**Appendix I – Response to Comments on the 90% Design Documents (Basis of Design Report, O&M Manual, Construction/Remedial Action Work Plan)**

Groundwater Remedy Basis of Design Report/Final (100%) Design

PG&amp;E Topock Compressor Station, Needles, California

**Design of New 12-inch Freshwater Pipe for Use if Pre-treatment is Required**

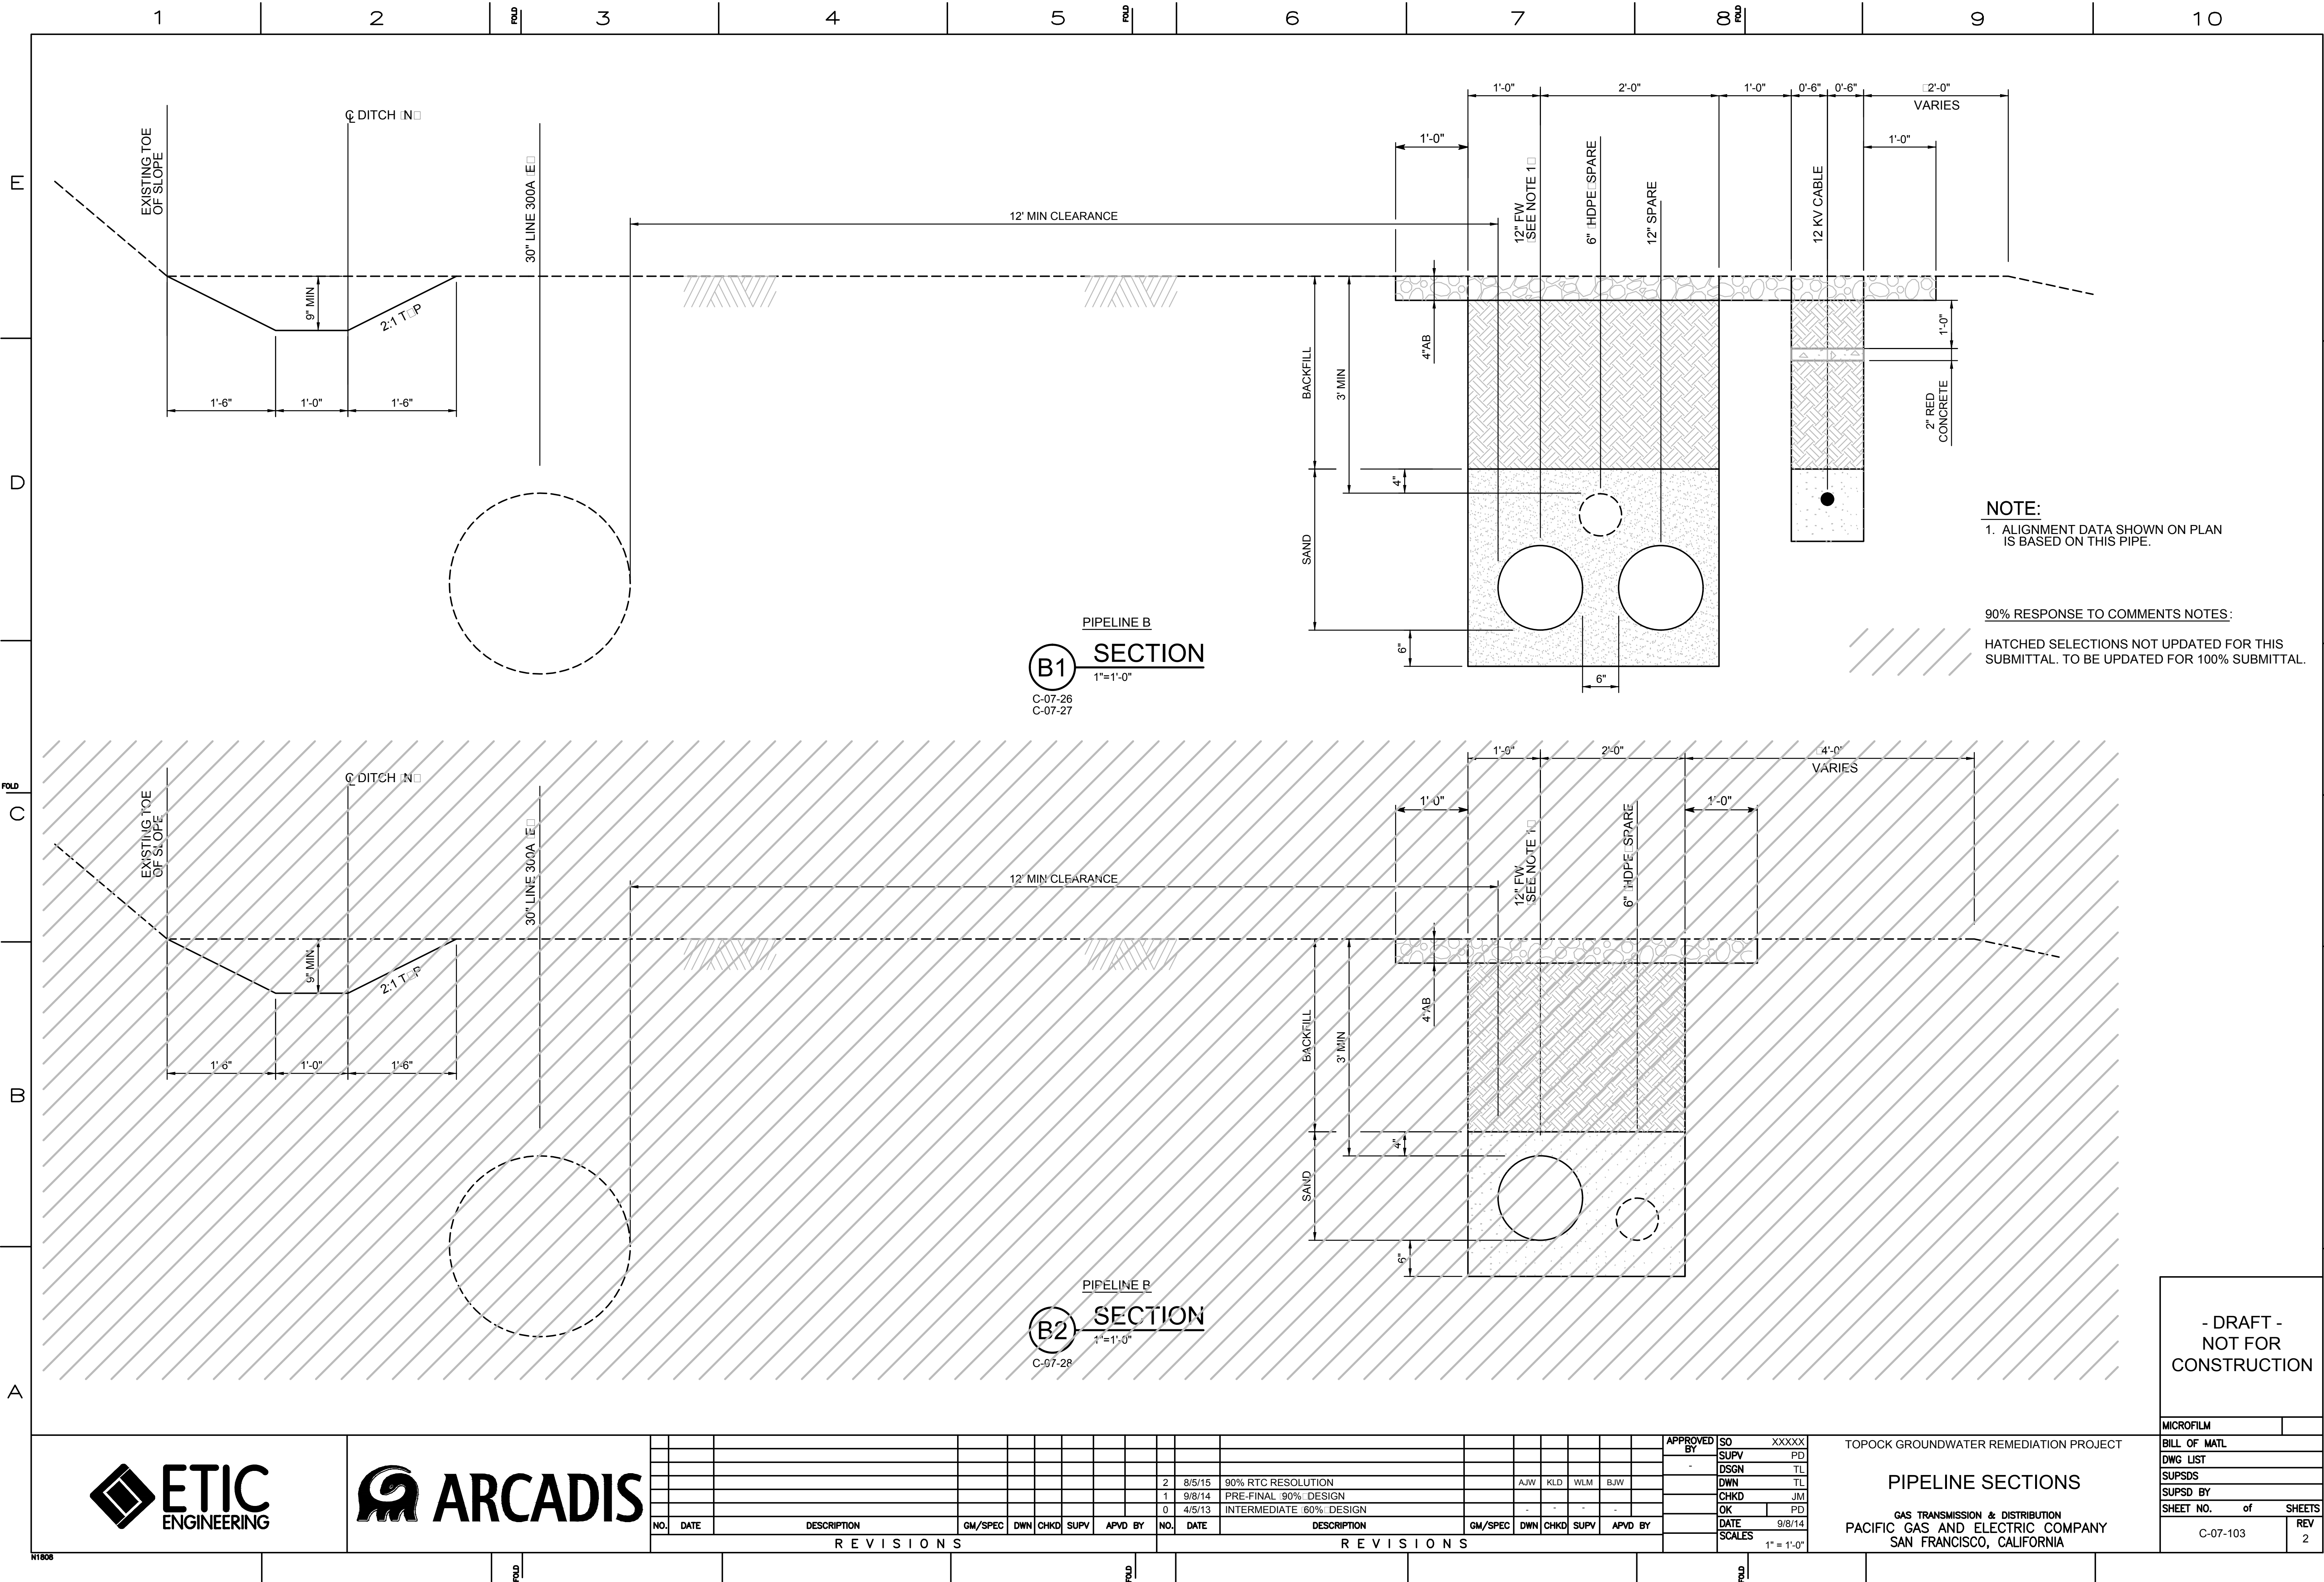
298	Cocopah/TRC	Design	Request for Information	3.3.3.1 Figure 3.3-1 Freshwater Supply Piping Network	In the event that pre-treatment of fresh water is required, all fresh water will be piped to the Compressor Station for treatment, and the treated fresh water will be conveyed along the entrance road prior to joining the freshwater	Please discuss how pipeline runs will be modified in the case that pre-treatment is required. How much new pipeline and/or trenching will be required. What will the new flow paths be in the case that pre-treatment is required?	See above			The incorporation of design accommodations for possible future additional pipeline runs, while planned for in existing trenches, represents an incremental expansion of underground piping that needs to be addressed in the SEIR.	DTSC response: Tribal comment noted.

Revised C/RAWP Figure 4.2-3

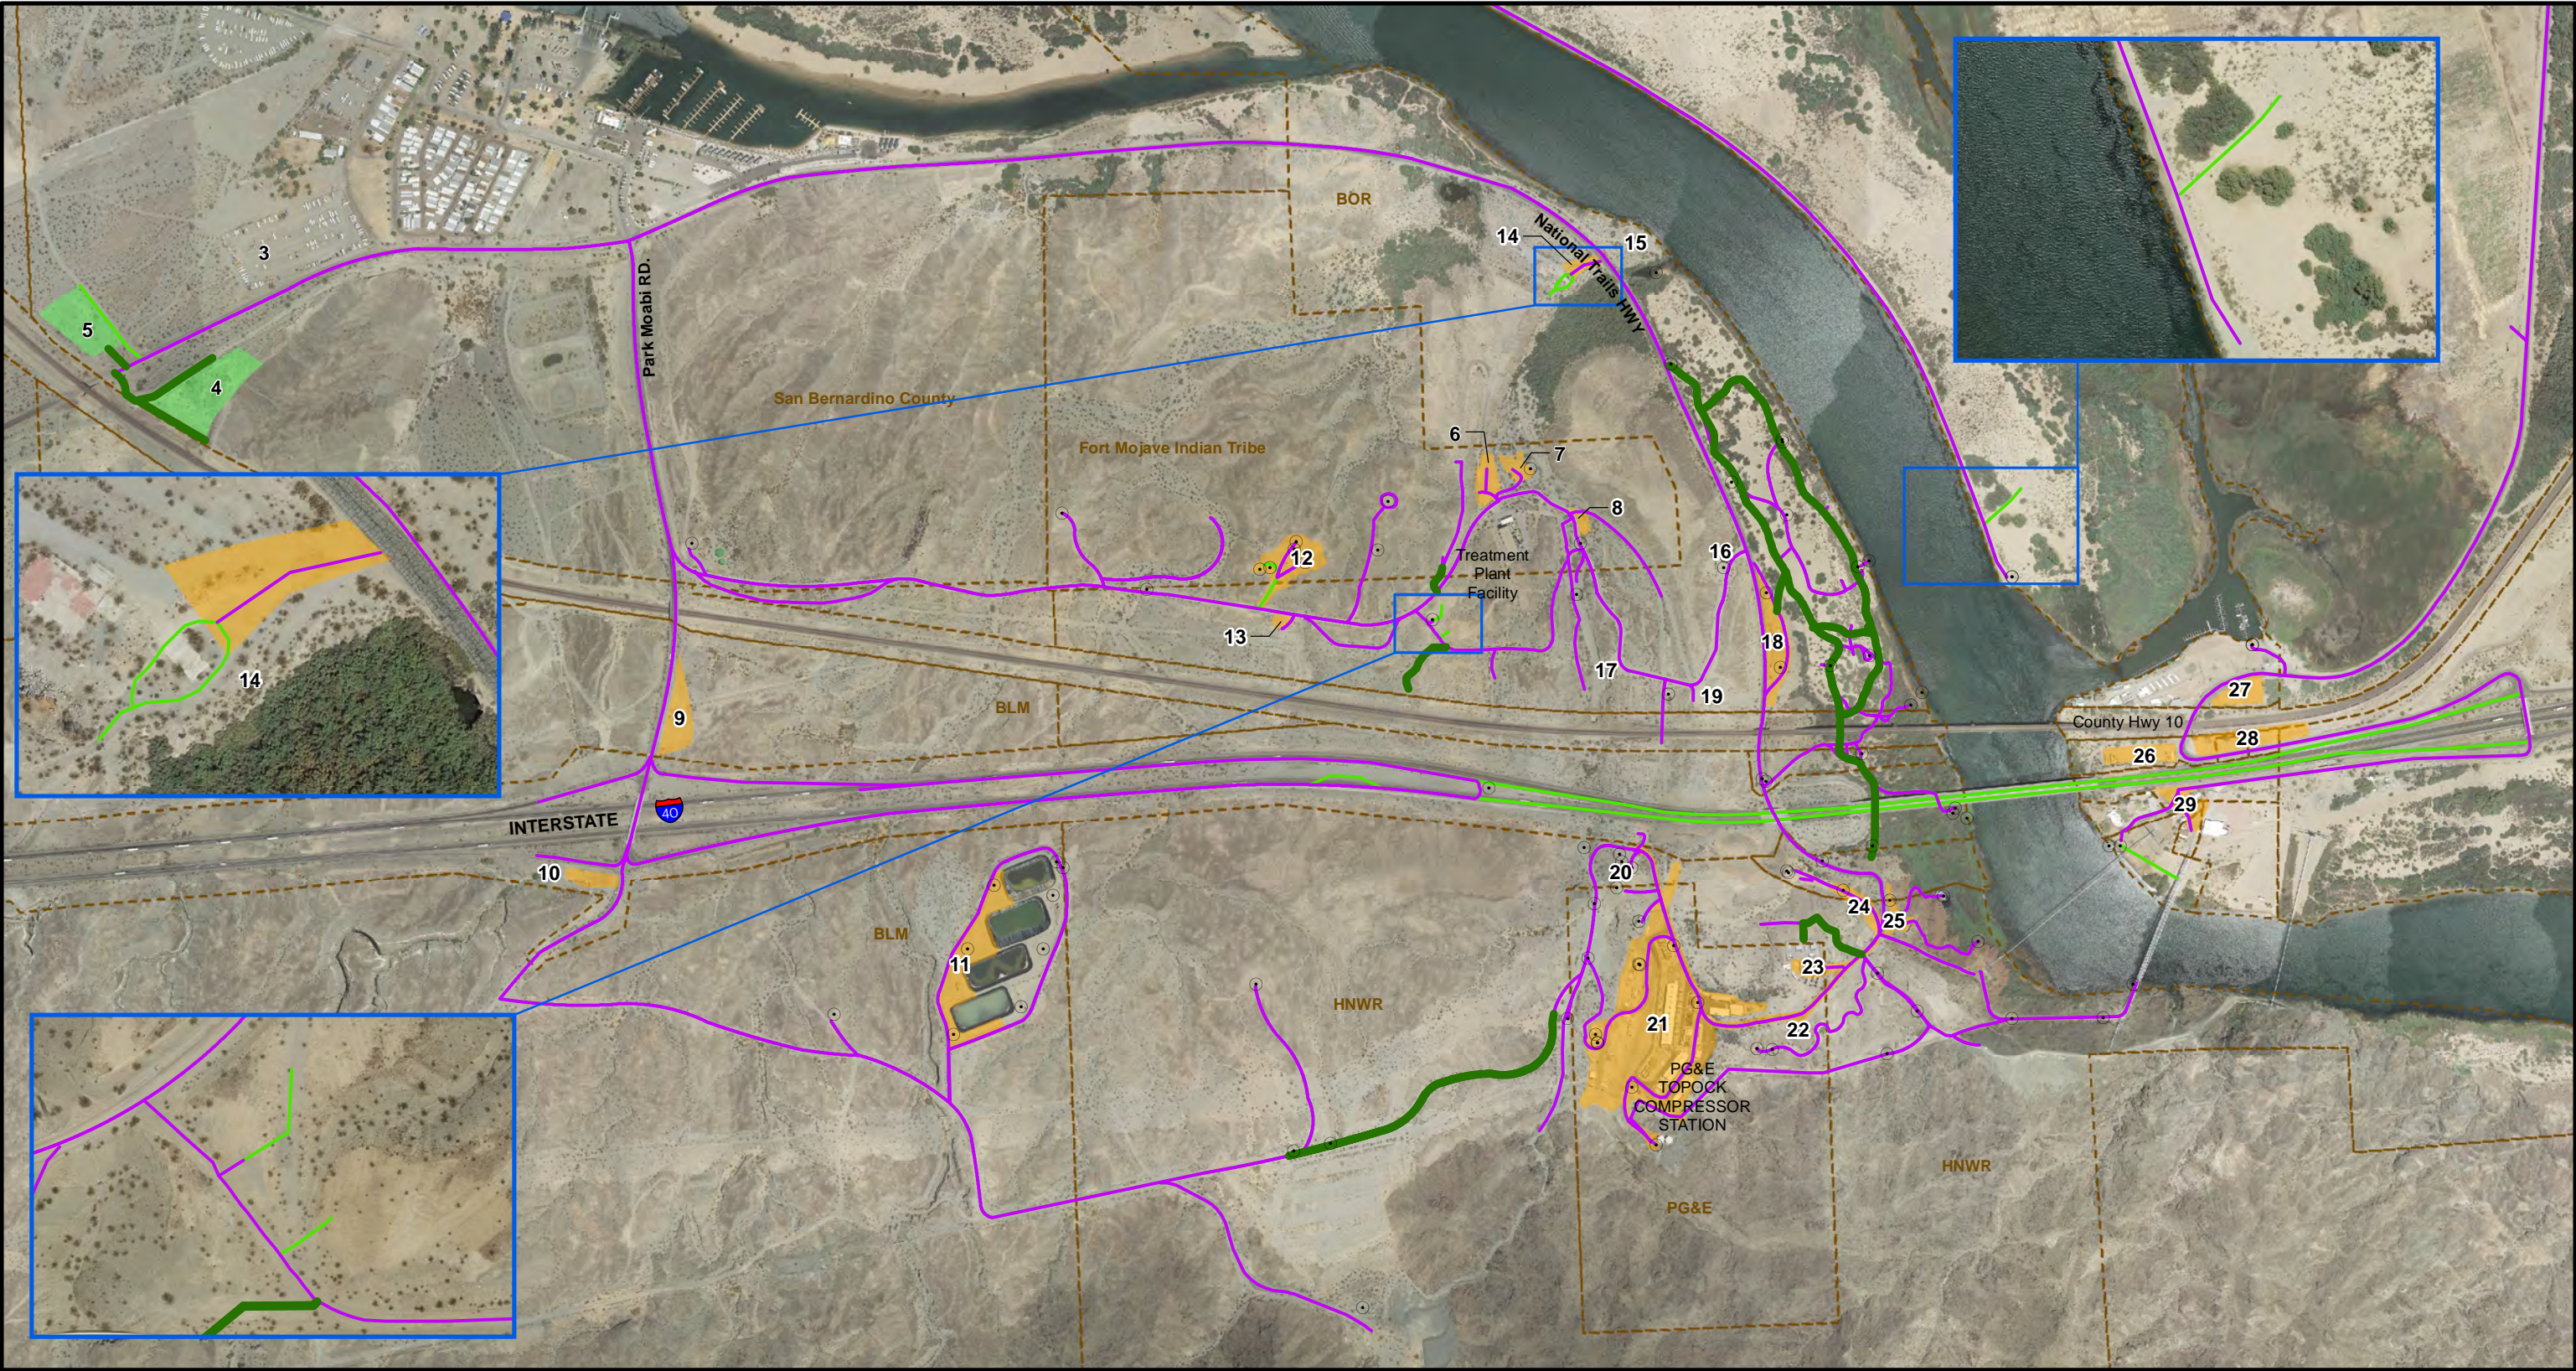
105	FMIT-20	Design	Infrastructures	ES.3. p. x	5 <sup>th</sup> bullet describing staging areas and support zones	FMIT is opposed to certain staging areas/support zones identified. This is discussed further in regard to Figure 4.2-3 of the C/RAWP.	Please see RTC #860 FMIT/TRC, #861 Hualapai/ TRC, #862 Cocopah/TRC, and #863 Chemehuevi/TRC.				This RTC and other RTCs related to staging areas were discussed at the July 23, August 19, and August 26 TWG meetings.
106	MWD	Non-design	Other	ES-4/xi; Sect. 5.0/5- 1; Figure 5.1-1	Institutional Controls	Figure 5.1-1 shows the line for the approximate area for Category 1 Institutional Control going through the top left corner of Metropolitan's property. Section 5.0 is silent on property owned by Metropolitan that is within the southeastern area of the designated Area of Potential Effects (APE). Either the APE boundary should not include Metropolitan's property, or access and other control issues should be described.	As noted, the APE boundary includes a small area of MWD's property. At this time, PG&E does not propose groundwater remedial infrastructure nor plan to conduct remedial activities on MWD property. Therefore, PG&E does not request access to MWD's property for the purpose of remedial or investigative activities.  Further, in discussions with DTSC and DOI, a Category 1 IC is determined to not be necessary at this time by the Agencies for the MWD property. The need for and effectiveness of institutional controls for the remedy will continue to be evaluated in the		The APE refers to the geographic area or areas within which an Undertaking may directly or indirectly cause alterations in the character or use of historic properties. The APE for this Undertaking was initially comprised of 1,600.69 acres of surface area, 325 and a section of the Colorado River. The Programmatic Agreement (PA) notes that “At each phase (workplan or design document) of implementation of the Undertaking, an evaluation will occur to determine if the APE should be amended.” This		Comment resolved.
